Landscape Referral Response

Application Number:	DA2022/1057
Date:	13/07/2022
Responsible Officer:	Thomas Prosser
Land to be developed (Address):	Lot 12 DP 238220 , 8 Chatham Close BELROSE NSW 2085

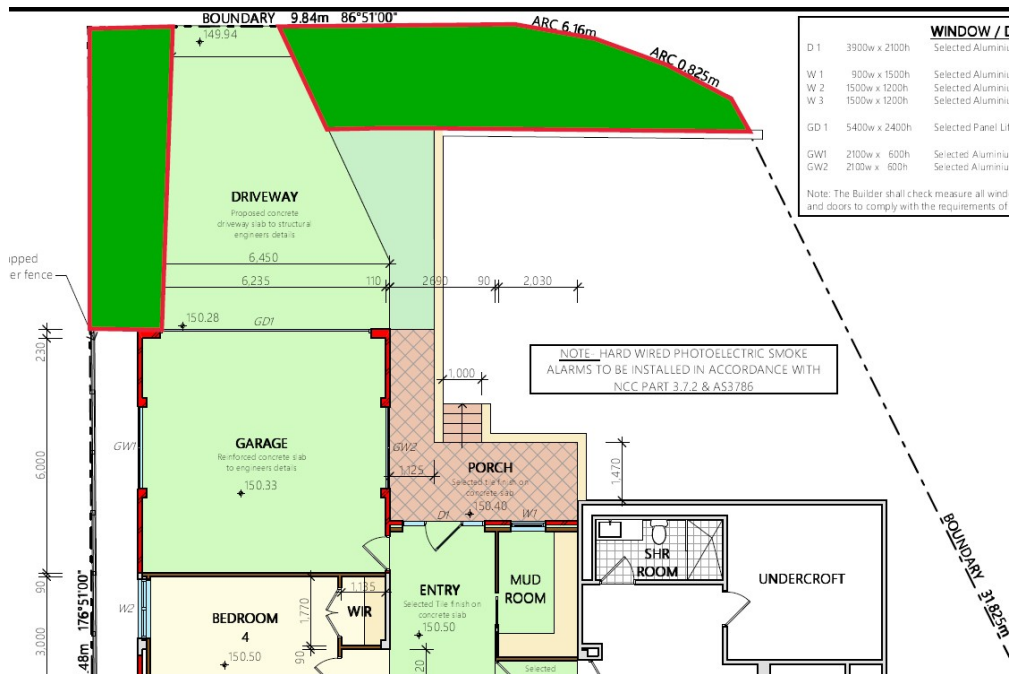
The application proposes to remove two native trees and mature landscape from the front setback which currently help to satisfy DCP control D1. The two trees, proposed to be removed, are the only trees located within the property boundary and no replacement trees are proposed. Landscape Referral raises concerns that the rooftop garden, above the proposed garage, will not have sufficient soil depth to support planting. The perimeter raised garden beds can be supported (if shrub planting is proposed and a minimum 600mm soil depth is achieved); however, the small area of paving and glass balustrade shall be removed and the raised garden bed shall continue along the northern edge. The perimeter raised garden beds shall also have a minimum internal width of 600mm. The lower planting area (of the roof top garden), around the 'floating' pavement, does not appear to have sufficient soil depth, and more information is required. A minimum 600mm soil depth must be provided for shrubs and 300mm soil depth for native grasses and groundcovers.

Based on lack of information regarding landscape design, and the departure from the DCP controls D1 and E1, Landscape Referral are unable to support the application at this stage. More information is required in the form of a Landscape Plan which shall propose:

- two replacement trees (species, location and pot sizes) to achieve a minimum 6m height at maturity and be selected from Northern Beaches Council's Native Plant Species Guide - Frenchs Forest Ward, or Council's Tree guide,
- the proposed planting for all front setback garden areas (showing species, location quantities and pot sizes). Mass planted garden beds shall be at minimum in the areas shown in green below,
